P 533738

**ON-SITE SEWAGE DISPOSAL SYSTEM
TANK REPLACEMENT
HOWARD COUNTY HEALTH DEPARTMENT
BUREAU OF ENVIRONMENTAL HEALTH**

ADDRESS: 11335 Frederick Road PROPERTY OWNER: James and Mildred Coroneos

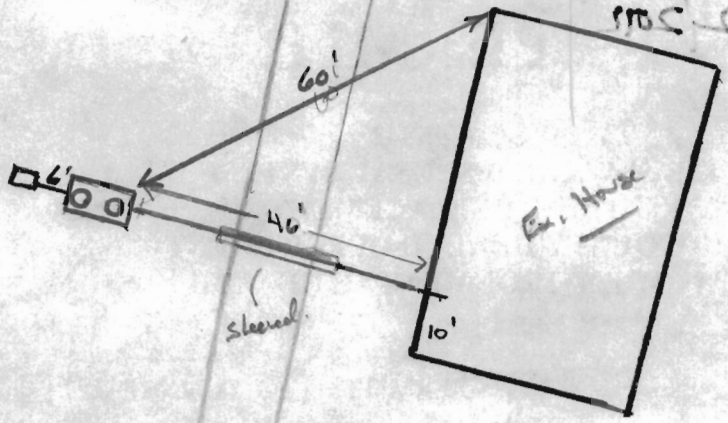
Set septic tank (replacement) 15' west of driveway with 3 feet or less of soil over tank. Tank should align with 4" PVC (existing). Sleeve SHC under driveway. Contractor to expose SHC and 4" PVC for layout inspection. Call for layout inspection. Attending Environmental Sanitarian may require evaluation of existing drain field. Pump, crush and fill old tank for final approval of this permit.

6/14/12 Met w/ contractor on-site. Keep new S.T. @ least 20' from dwelling. sleeve the under drive way. Pump, valleys ex, septic tank. Homeowner wants to use 6" sch 40 from house to tank. I am ok w/ 6" sch 40 to tank. Just make sure tank has 6" core hole on inlet side. (KW)
